U.S. Department of Energy
Office of River Protection

04-WTP-268

U.S. DEPARTMENT OF ENERGY (DOE), OFFICE OF RIVER PROTECTION (ORP)
RESPONSES TO THE DEFENSE NUCLEAR FACILITIES SAFETY BOARD (DNFSB)
CONCERNS

Responses to Issues Raised in July 21, 2004 Defense Nuclear Facilities Safety Board (DNFSB) Letter Regarding Waste Treatment and Immobilization Plant (WTP) Ventilation Systems Design

RPP-WTP Pretreatment Facility ISRS

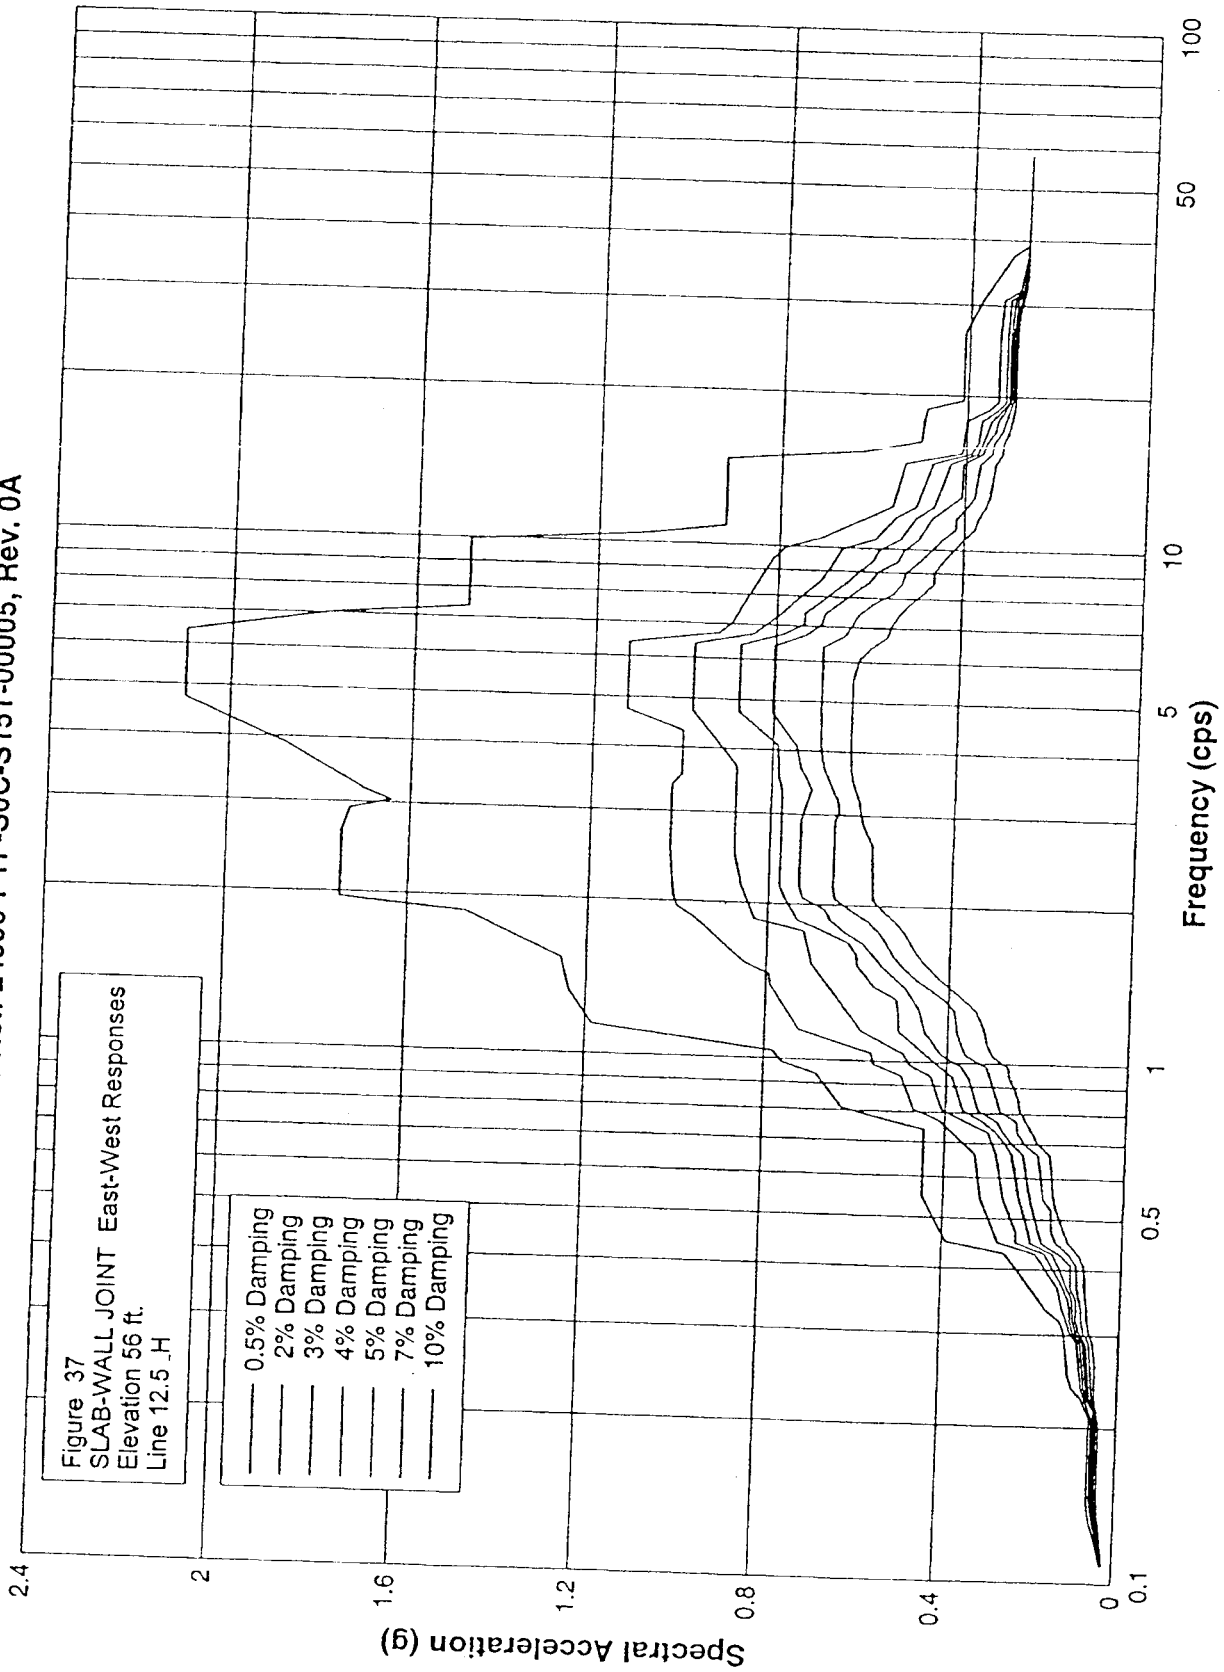
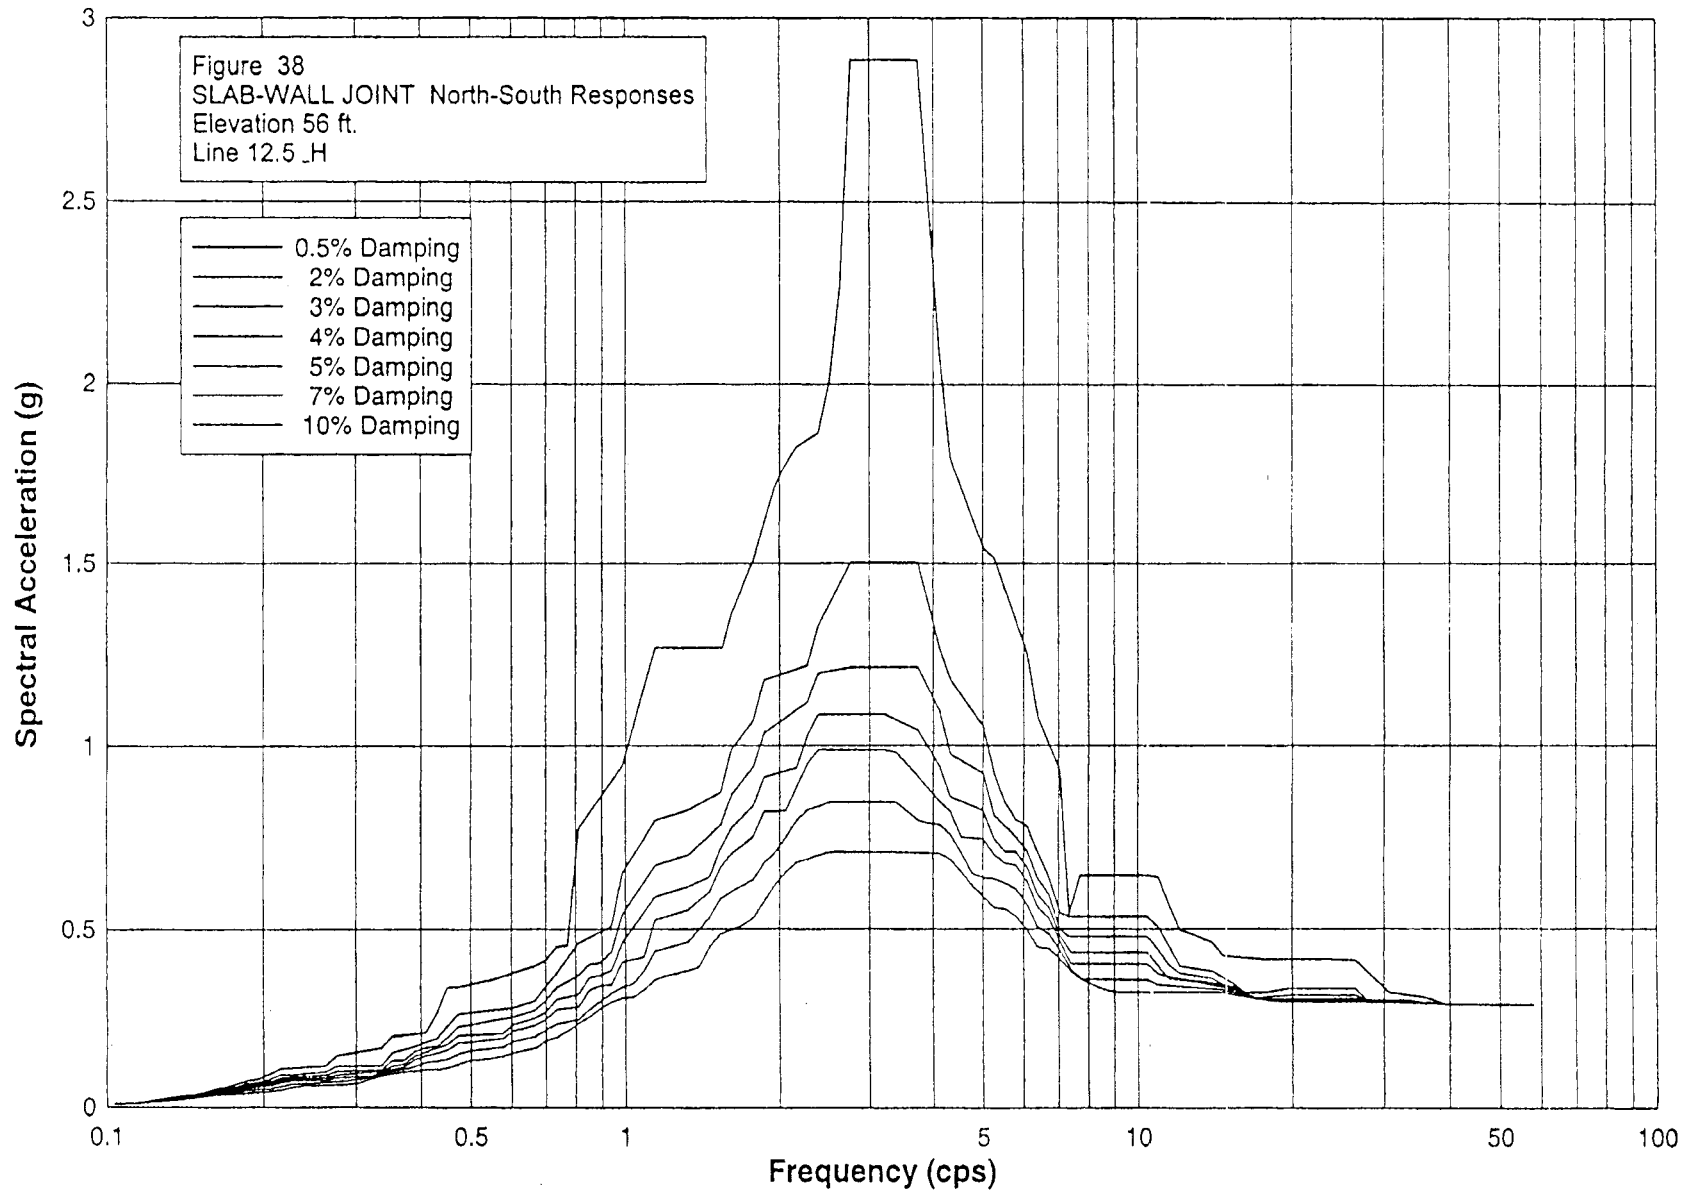
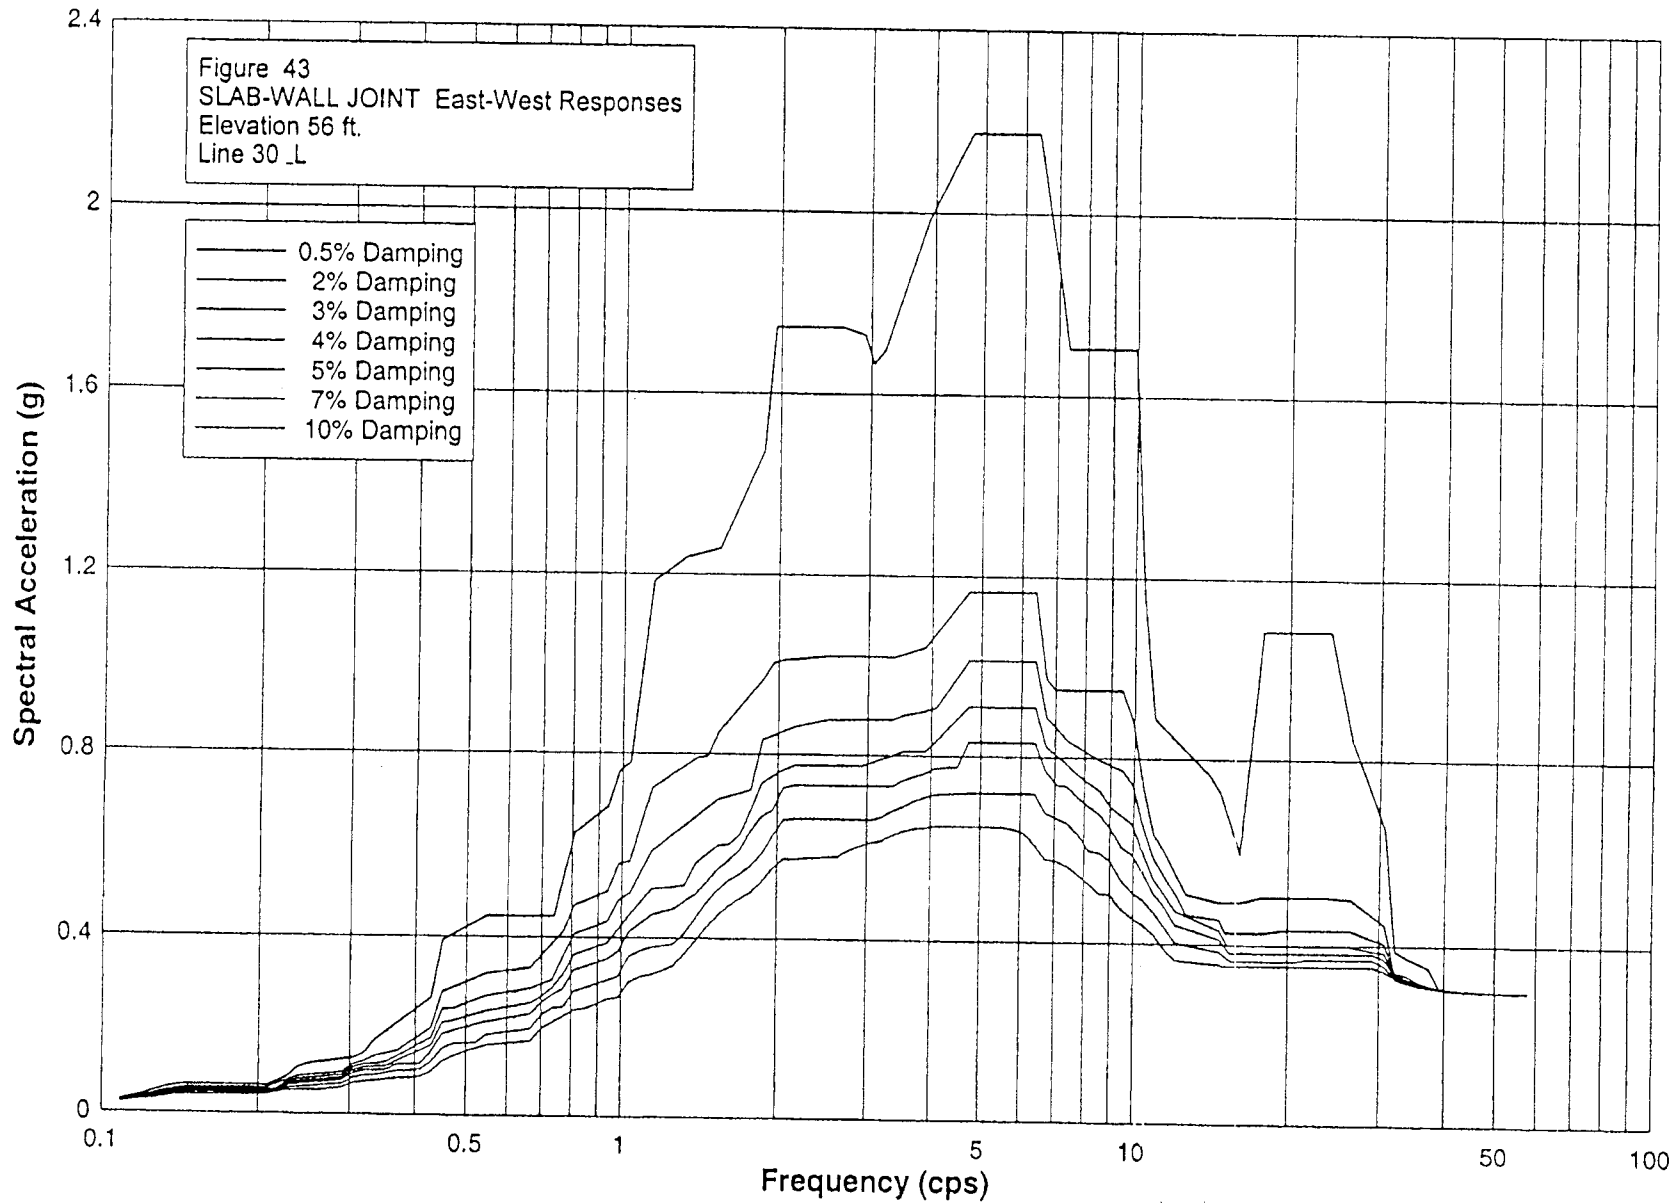
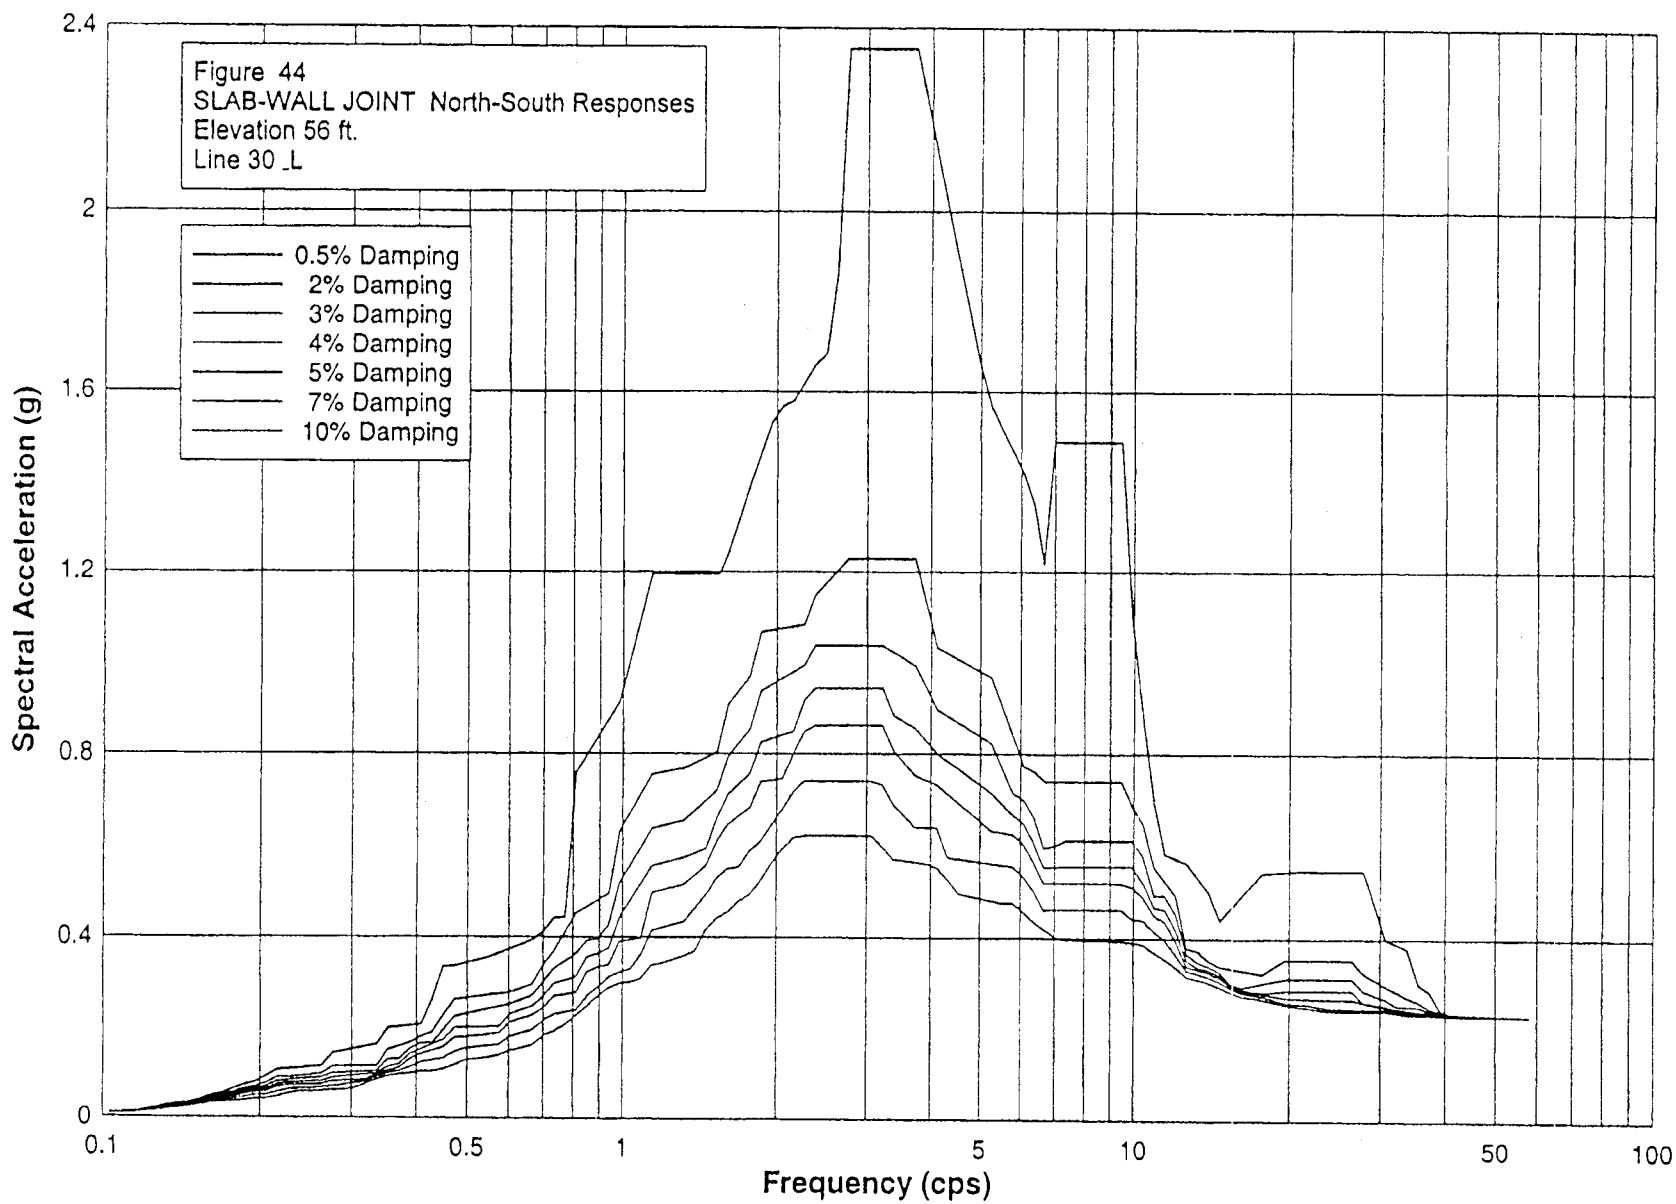
WTP-04-281-02 The planned ventilation filter housing shaker table tests will use a bounding seismic spectra as input for the shaker table tests. The staff wants to review the bounding data for suitability.

Response: The WTP Project will not use bounding data for the PT and HLW facilities. The specific In-Structure Response Spectra (ISRS) curves for each facility will be used and separate testing for each facility will be conducted. The applicable curves, by elevation and column line, for the Remote Change HEPA Filter housings will be used which shows the expected frequencies and accelerations in the north/south, east/west, and vertical directions. The reason for applying the ISRS curves specific to each building and not using bounding data is as follows:

The Remote Change HEPA Filter Housings in the PT and HLW buildings will require separate testing for the following reasons:

- a) The housings are supported by steel platforms. Since the platforms are not rigid, they need to be simulated for testing. The platform configurations are different. Therefore, their simulations would be different, requiring separate testing.
- b) ISRS for PT and HLW buildings are different.
- c) It is likely that the external loads on the housings, e.g., connected ducts, in PT could be different from those in HLW.

Enclosed are the ISRS curves applicable to the Remote Change HEPA Filter housings in the HLW and PTF facilities.†
